MECHANICAL SYMBOLS AND SERVICES

MECHANICAL DEMOLITION PLANS

1 / M100 LEVEL 01 - ENTRANCE DEMO PLAN
1 : 100

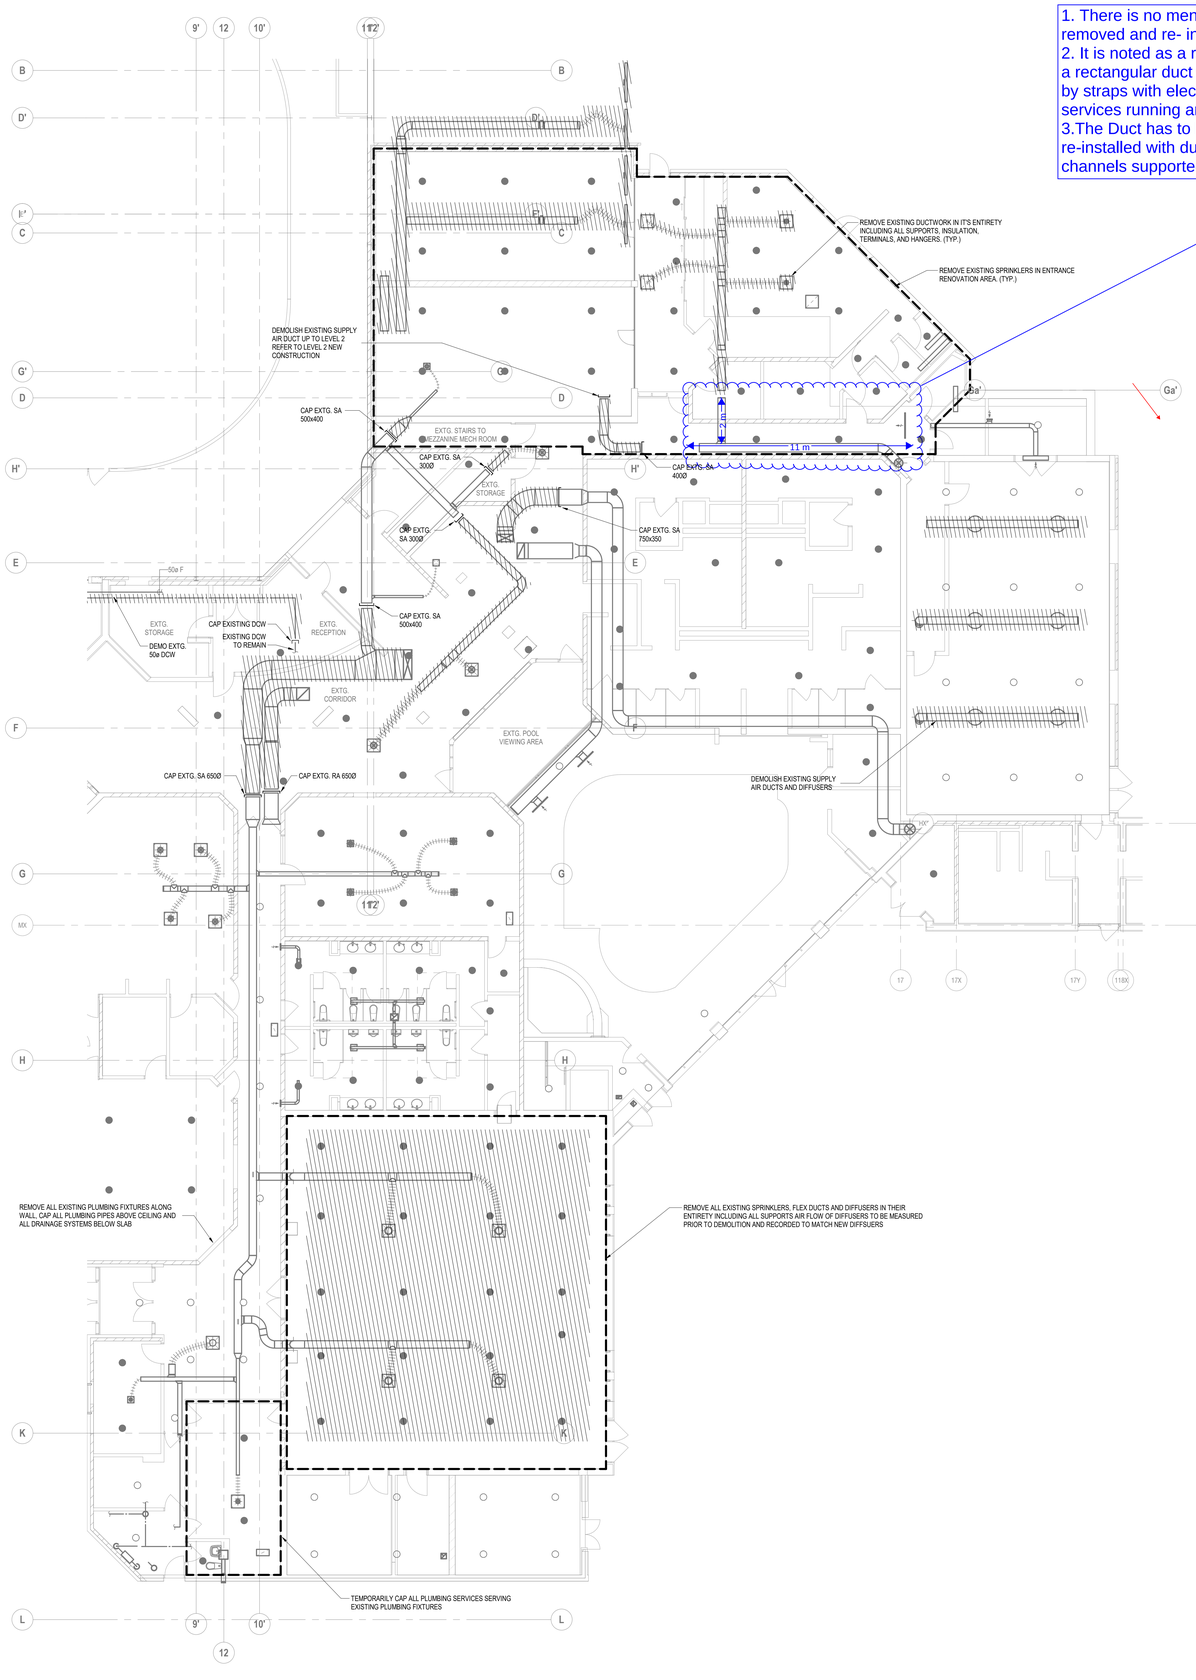
1. There is no mentioned of this Duct being removed and re- installed.
2. It is noted as a round duct but on site its a rectangular duct with Duct heaters hung by straps with electrical and plumbing services running around it.
3.The Duct has to be removed and re-installed with duct on the slotted channels supported by rods.
